Subject: Completeness Items for CU-2018-003

We are providing this letter and attached materials in response to your incompleteness letter dated January 4, 2019 for a proposed senior living facility at 13333 SE Rusk Road. The incompleteness items identified in your letter are listed below along with a response indicating how they have been addressed.

BONAVENTURE SENIOR HOUSING
 PRELIMINARY SITE PLAN
 BONAVENTURE SENIOR HOUSING
 MILWAUKIE, OREGON
 13333 RUSK ROAD MILWAUKIE, OR 97222

**Bonaventure Senior Living
TPC Landscape Area**
Milwaukie, Oregon

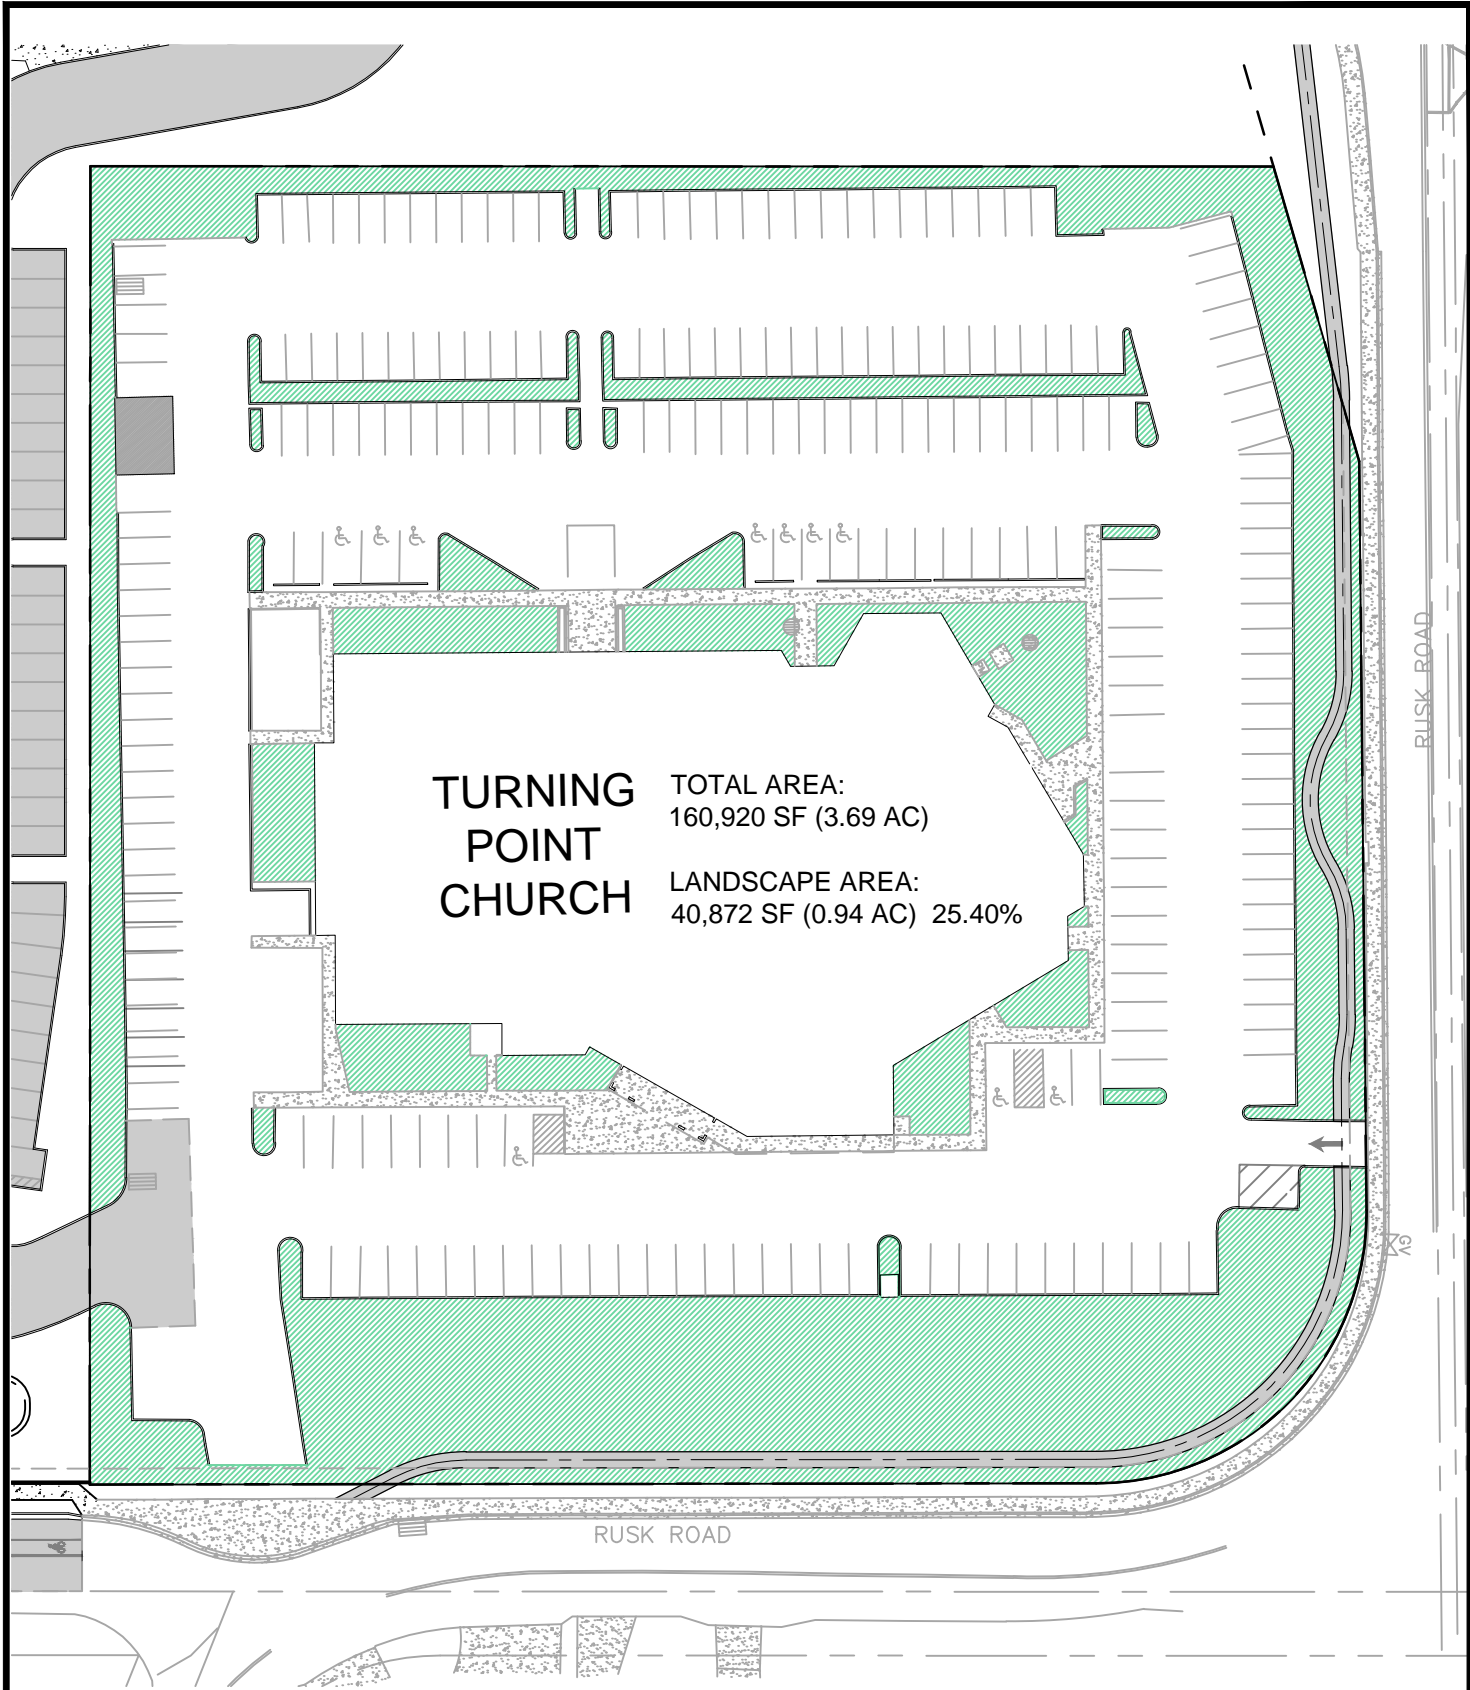
The proposed boundary change to place the Turning Point Church on a separate lot significantly reduces the amount of landscaping on the church site. It is not clear from the application materials whether the proposed change will reduce the minimum required landscaping below the level allowed for institutional and religious CSUs (15% of the site area). The materials should be revised to address this issue and include a variance request if necessary.

Response: An attachment is provided with this submittal to demonstrate the amount of vegetated area that will remain on the church property. As shown in Attachment 1, approximately 25 percent of the church site will be vegetated, which exceeds the requirement.

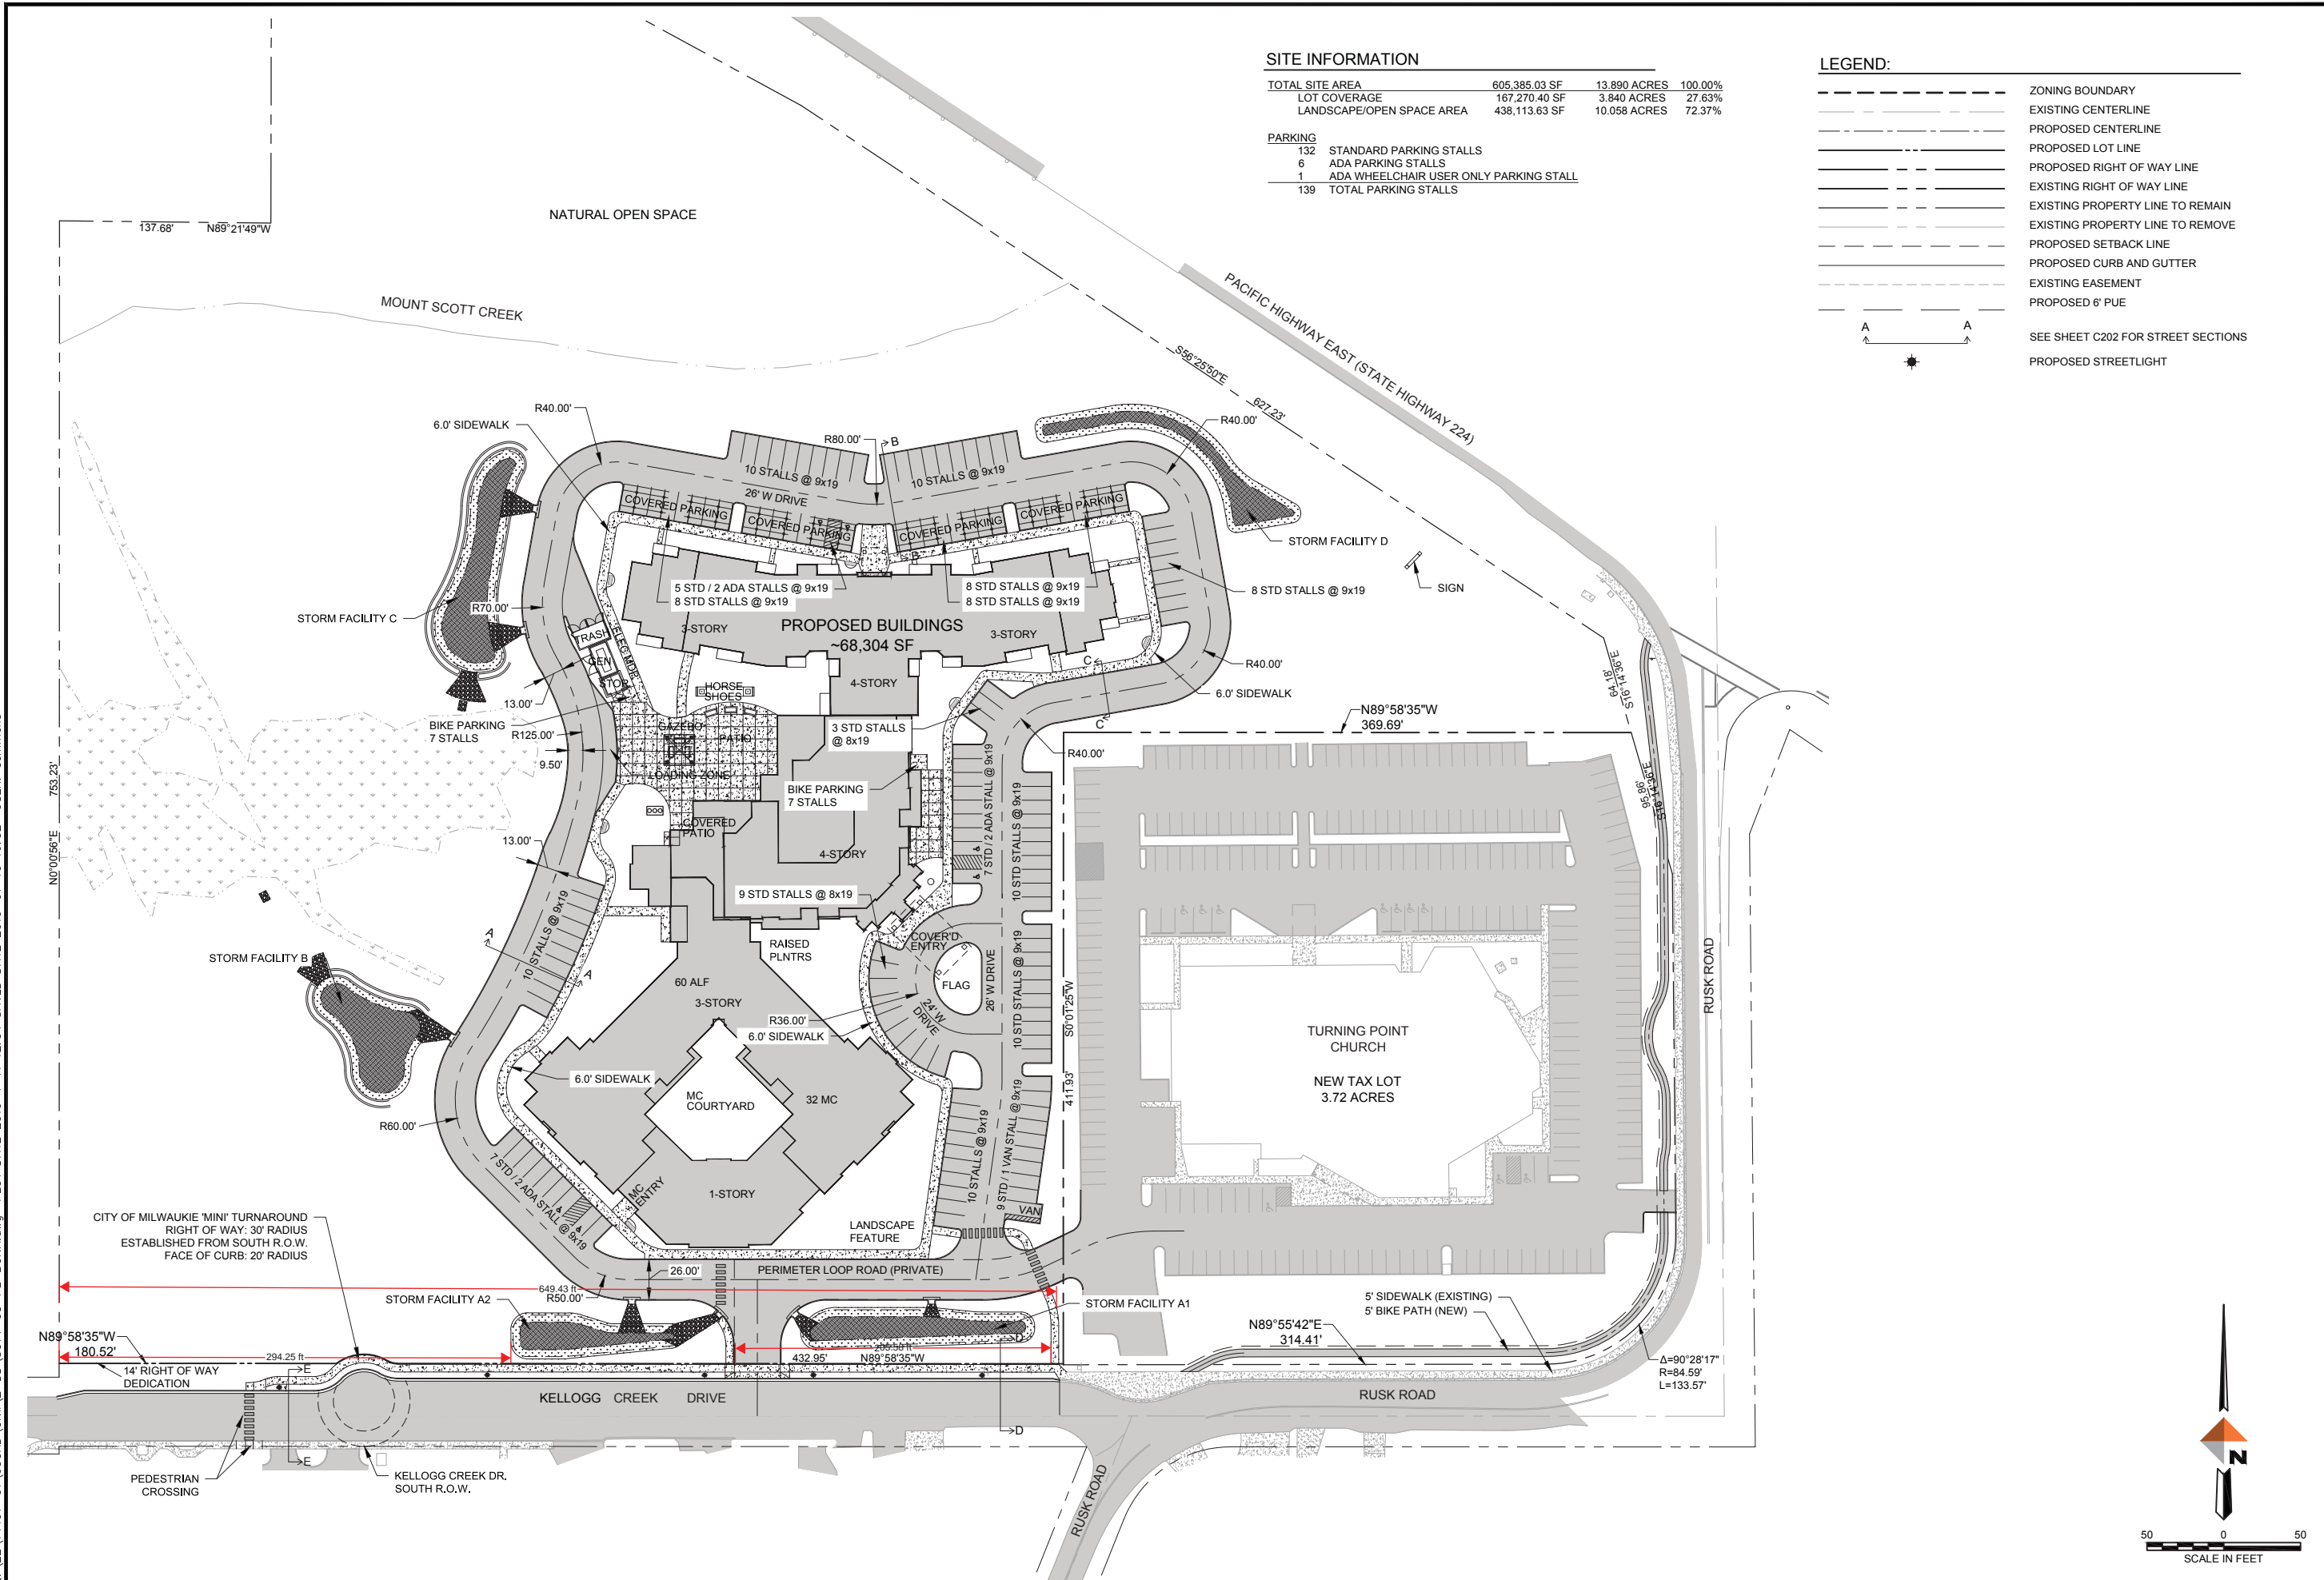
A walkway into the site is required for every 300 ft of street frontage (MMC Subsection 19.504.9.B). As noted in the narrative, the frontage on Kellogg Creek Dr exceeds 600 ft, so 2 walkway connections into the site are required. The site plan shows 1 connection at the driveway onto Kellogg Creek Dr, and the narrative indicates that it is not appropriate to provide a second connection. That may be the case, but a formal variance request is required if relief is sought from the standard. The same is true for the limited site frontage on Rusk Rd (approximately 64 ft, which requires 1 walkway connection).

The requirement for bicycle parking applies to community service uses, which includes the proposed memory care units. While it may be true that bicycle parking is not necessary for memory care residents themselves, the spirit of the requirement extends to employees and visitors. If bicycle parking will not be provided, a variance request is required. If the applicant wishes to make the case that bicycle parking should be required at a level less than 10% of the vehicle parking spaces, that could be addressed in the applicant's requested parking determination, as per the procedure outlined in MMC Subsection 19.605.2.

Response: The site plan has been revised to show an additional connection into the site from Kellogg Creek Drive, located at the eastern edge of the site next to the church property. For the limited site frontage on SE Rusk Road, the applicant is requesting a variance to the standard. The narrative has been updated to include the variance request and address the applicable variance criteria.

Response: The site plan has been updated to include 14 bicycle parking spaces (which is 10 percent of the 139 vehicle parking spaces on the site). The narrative has been updated to reflect this change and address applicable bicycle parking standards.
